7/3/2024 – 1st Review Comment Letter

RE: **12-DR-2024**
The Bishop
918N8 (Key Code)

LOCATION 2

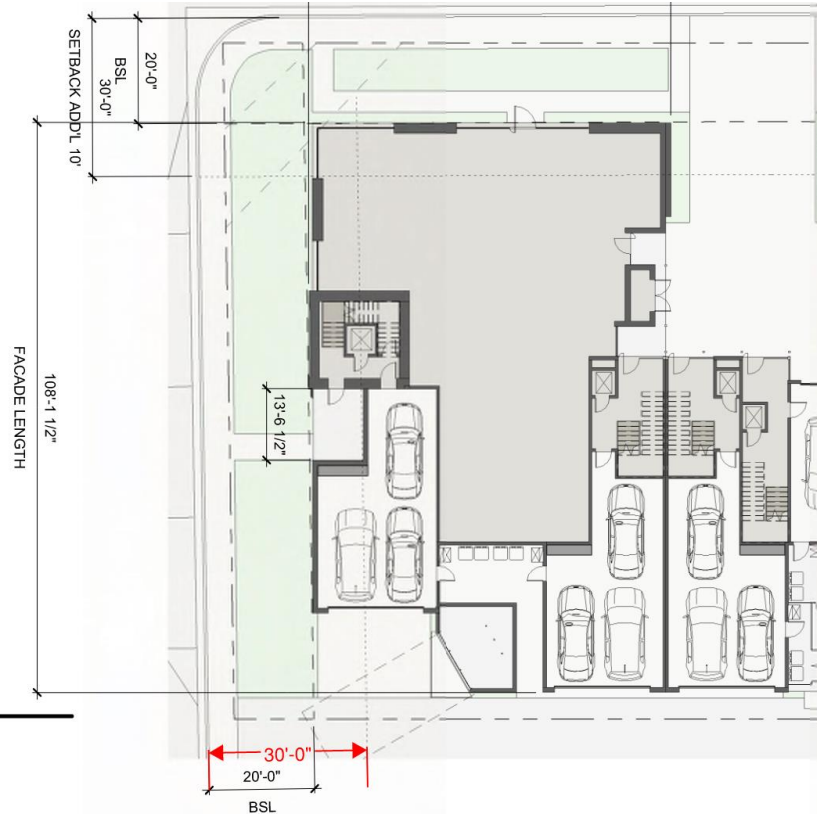
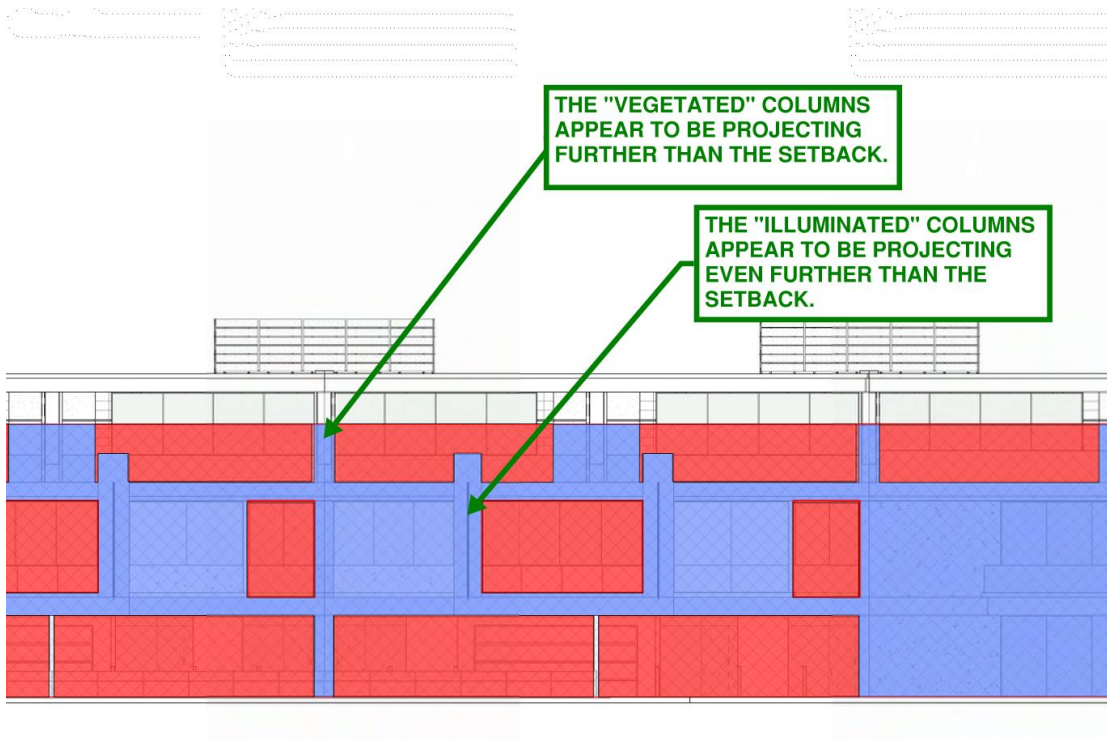
16. Building Location: ii. Length of building façade @ grade and up to a height of ~~45'-30'~~ shall be setback at least 10 additional feet (north façade) – Level 1 Façade 2 is only showing 13'-6 ½" at the 30-ft setback line, but the summary table indicates that 29'-5" is setback at the 30-foot setback line. Please clarify and update plans accordingly:

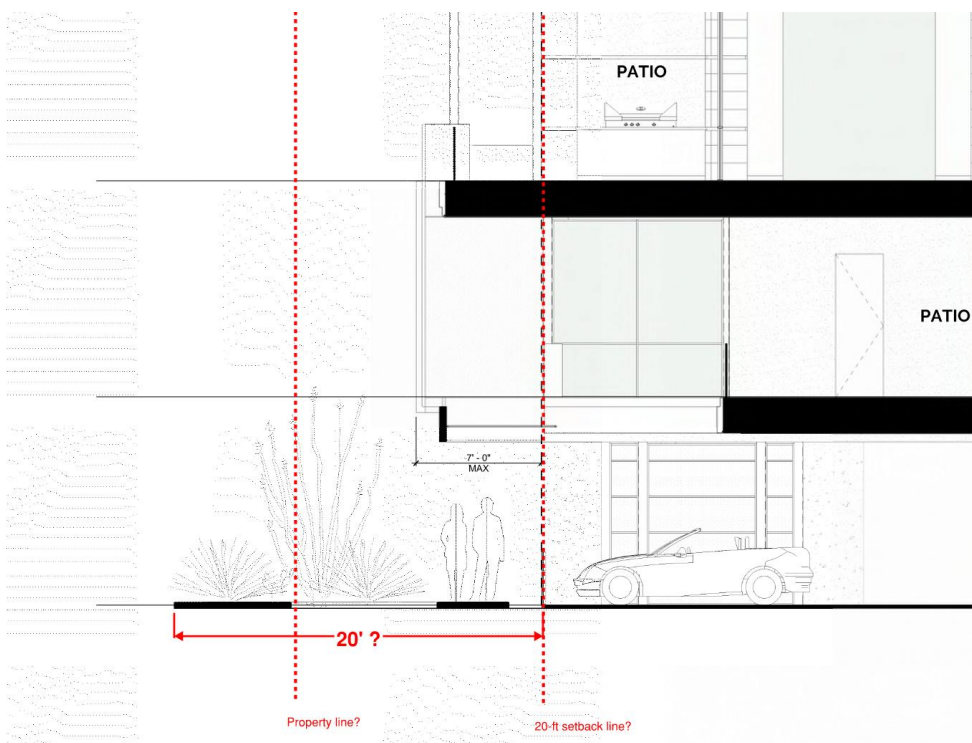
17. Building Location: iii. Area of the building façade at grade and up to a height of ~~45'~~ **30'** shall be located at the min. setback line (east façade) – East Elevation Façade Location 3 is including parts of the façade that are not located at the building setback line including the “vegetated” columns and the larger “illuminated” columns. Please remove any part of the façade from this calculation that is not located at the min. setback line:

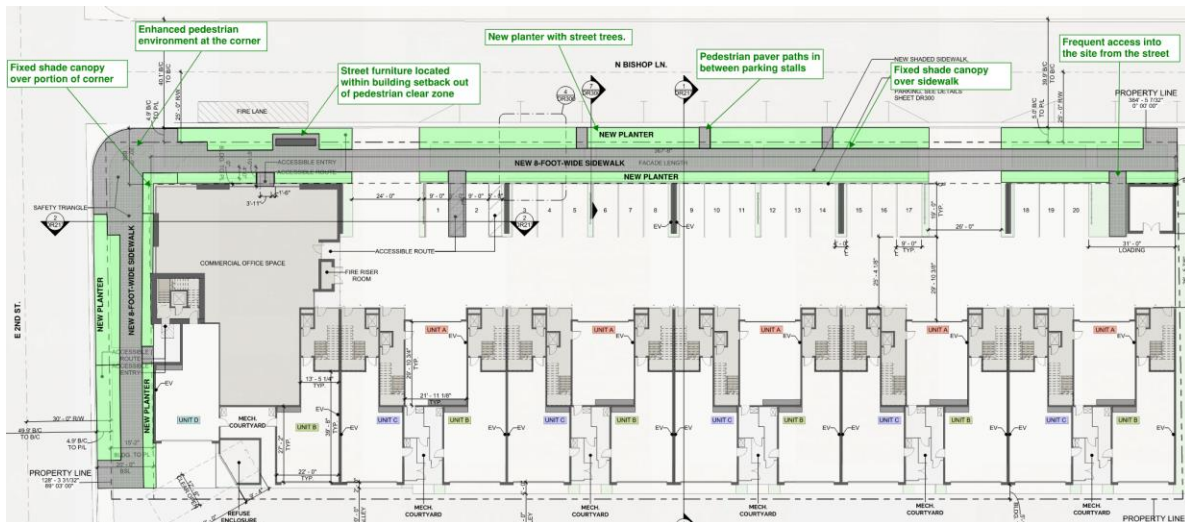
33. For individual water services for residential units and related sprinkler systems: confirm building code requirements for NFPA 13D residential systems (if that is intent). Clarify and confirm in resubmitted BOD. Confirm sprinkler plan for commercial space, along with riser room location and fire line.
34. Please see the following correction file(s) uploaded into the digital file exchange folder:
 - a. 12-DR-2024_1-Prelim BODs_Corrections.pdf
